6.6	248-250, 252-254, 256-258, 260-262, 264-270 NORMANBY ROAD SOUTH MELBOURNE, 203-205, 207-211, 215-217 NORMANBY ROAD SOUTHBANK
LOCATION/ADDRESS:	248-250, 252-254, 256-258, 260-262, 264-270 NORMANBY ROAD SOUTH MELBOURNE, 203-205, 207-211, 215-217 NORMANBY ROAD SOUTHBANK
RESPONSIBLE MANAGER:	GEORGE BORG, MANAGER CITY DEVELOPMENT
AUTHOR:	SIMON GUTTERIDGE, PRINCIPAL PLANNER FBURA
TRIM FILE NO.:	MINRA0003/2015
ATTACHMENTS:	<ol style="list-style-type: none"><li>1. Locality Map</li><li>2. Site 01 - Plans</li><li>3. Site 02 - Plans</li><li>4. Site 03 - Plans</li><li>5. Site 05 - Plans</li><li>6. Site 06 - Plans</li><li>7. Original plans summary</li><li>8. Site 01 - Draft conditions</li><li>9. Site 02 - Draft conditions</li><li>10. Site 03 - Draft conditions</li><li>11. Site 05 - Draft conditions</li><li>12. Site 06 - Draft conditions</li></ol>
WARD:	Emerald Hill
TRIGGER FOR DETERMINATION BY COMMITTEE:	Residential use in Fishermans Bend

APPLICATION NO:	<u>264-270 Normanby Road, South Melbourne (Site 01)</u> DELWP ref: 15/35822, Council ref: MINRA 0003/2015 <u>256-258 &amp; 260-262 Normanby Road, South Melbourne</u> (Site 02) DELWP ref: 15/35806, Council ref: MINRA 0004/2015 <u>248-250 &a

Fig. 1: The subject site and the opportunities in surrounding areas

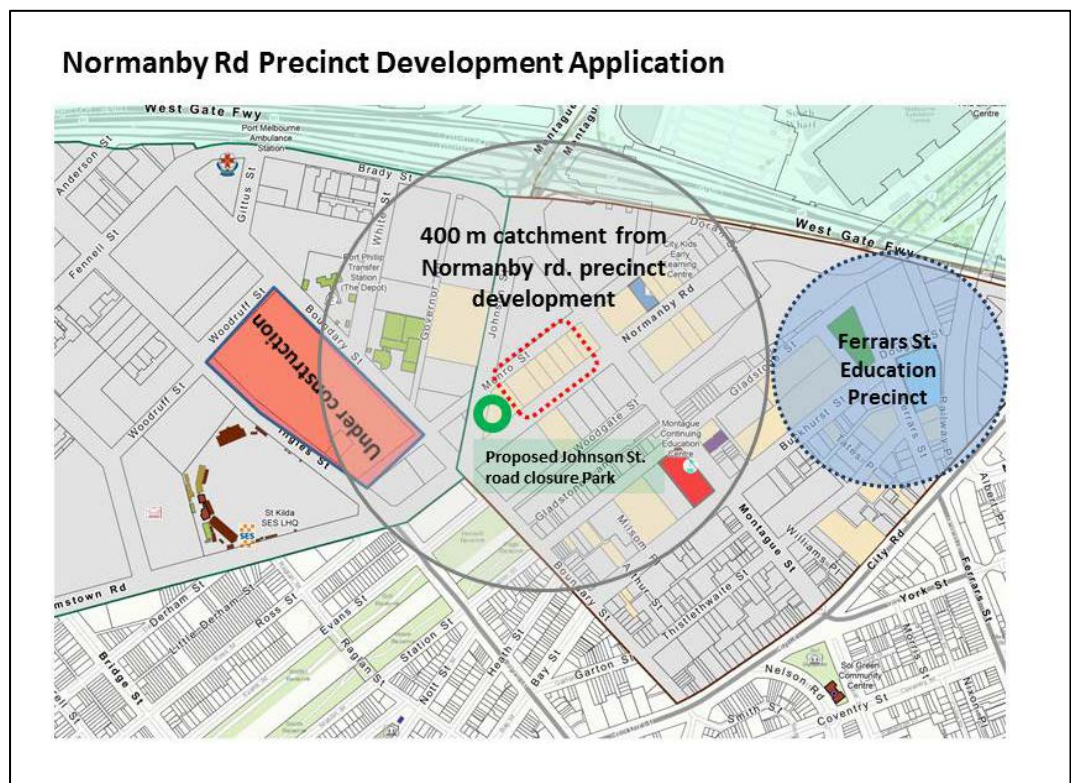
The four sites south-west of Montague Street are within a preferred area for 'mixed use development/provision of community infrastructure' in Council's draft *Fishermans Bend Community Infrastructure Plan*. The proximity of the four sites to the townhouse development under construction at 220 Ingles Street makes them a suitable location to deliver community services for the wider community. Additionally, the proposed Johnson St. road closure park (identified in the FBURA Strategic Framework Plan 2015) to the south-west of the subject site, would create a suitable place for co-locating community infrastructure and open space in the area. (The two sites to the north-east of Montague Street are not in a preferred location for community infrastructure).

Council's Community Infrastructure and Service Planner recommends that the sites south-west of Montague Street provide a mix of community infrastructure so as to create a 'small neighbourhood hub' accommodating retail and commercial uses along with community and health services.
